Date: April 9, 2021
To: Dan Duchniak, P.E.
From: Chris Walter, P.E.
Re: CP2A Work Change Directive

Great Water Alliance
Great Lakes Water Supply Program
CP2A - Water Supply Pipeline Section I, II and III
Station Suction Pipelines

WORK CHANGE DIRECTIVE

Work Change Directive No.:	004 Rev.: 0.00
Issue Date:	Monday, March 29, 2021
Subject:	HDD No. 2 Redesign - Additional Length
Reference Drawing / Specification:	C126 and C127
Workflow Status:	Submitted

SH-1
SHEET 1 OF 1

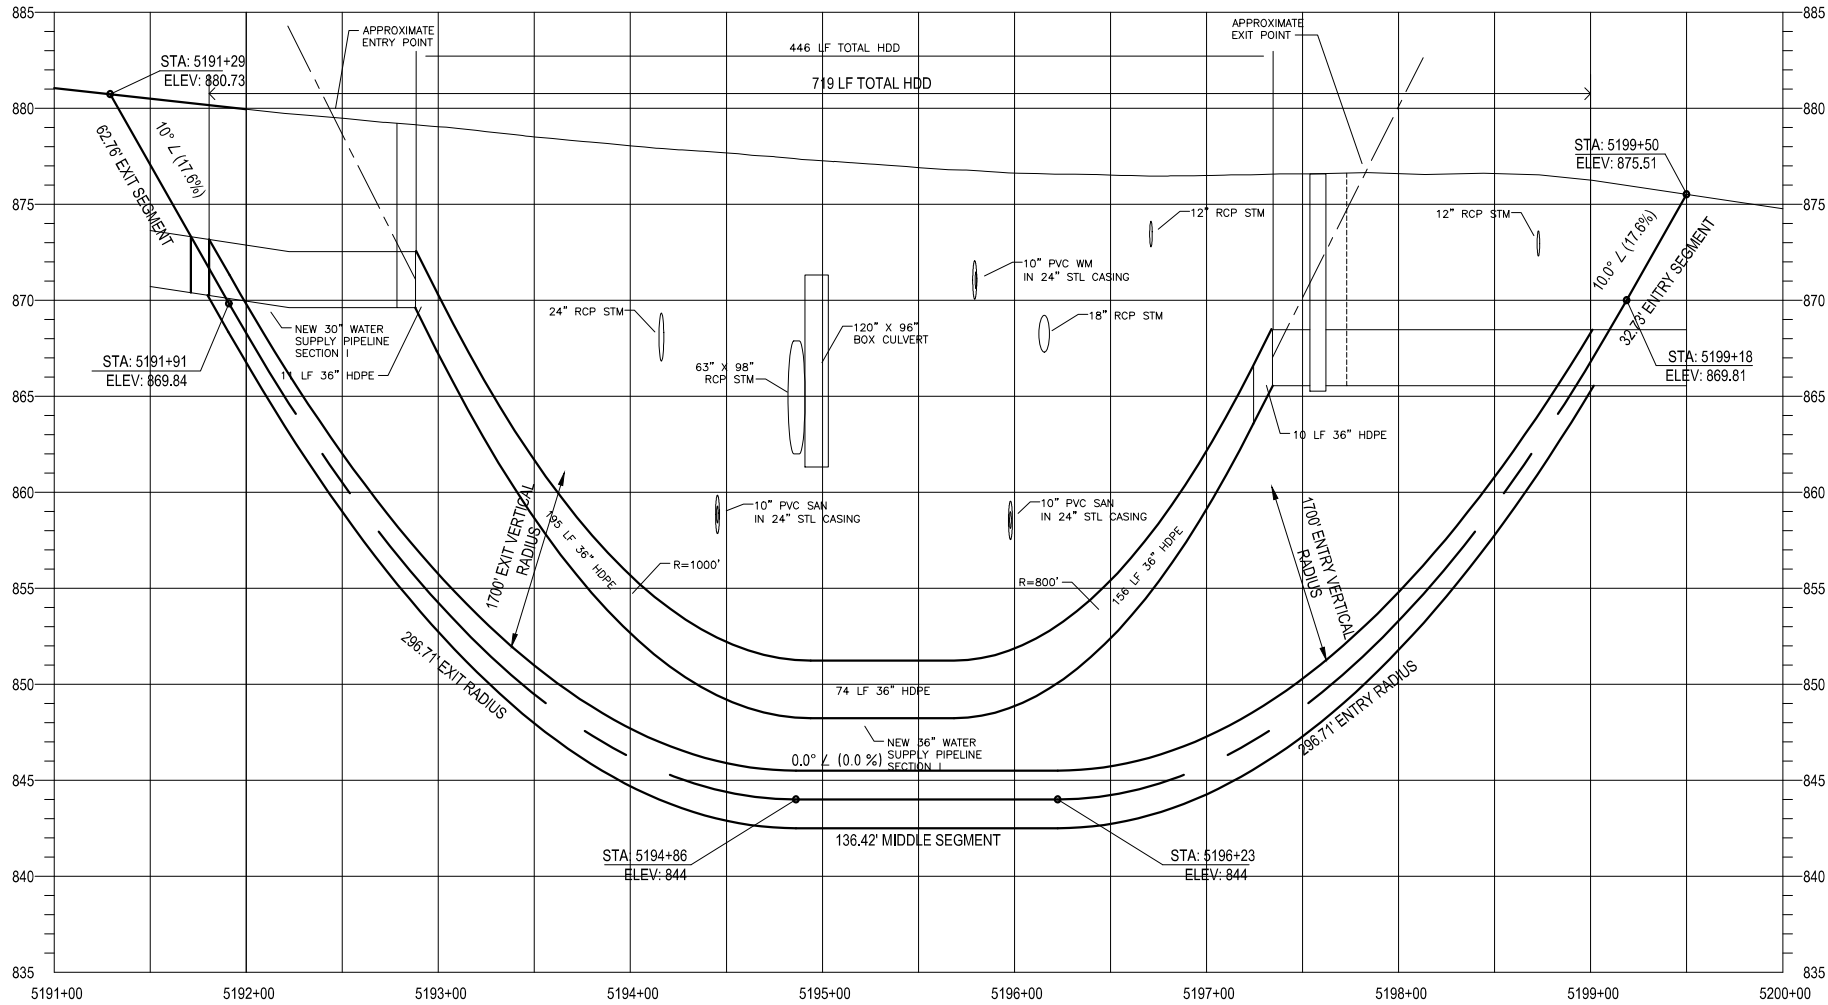
The purpose of Work Change Directive No. 004 is to redesign Horizontal Directional Drill (HDD) Crossing Plan No. 2 based on concerns by Super Excavators, Inc. An additional 273 feet of HDD length are requested by Super Excavators, Inc. to increase radius of curvature, increase clear spacing from utilities to decrease chance of utilities settling, reduce the risk of an inadvertent return, and reduce simultaneous horizontal and vertical curvature of the drill. All of the previously mentioned factors were said to reduce installation risk and increase probability of success.

Modifications to the Contract include all labor, material, and equipment cost to: Remove 273 LF of Ductile Iron Pipe, Open Cut 30-Inch Water Supply Pipeline Section I, Select Fill related to Contract Item 3-WS-I-B; Remove 208 TON of Base Course for Water Supply Pipeline Section I related to Contract Item 10-WS-I; Remove 93 TON of Water Supply Pipeline Section I, Asphalt related to Contract Item 11-WS-1-A; Add 273 LF of 36-Inch HDPE Pipe Horizontal Directional Drilling installation. Drawing SH-1 is included as an Attachment showing the changes associated with Work Change Directive No. 004.

RELOCATE ISOLATION VALVE
OUTSIDE OF HDD LIMITS

RELOCATE VAULT,
BLOW-OFF & TEST STATION
OUTSIDE OF HDD LIMITS
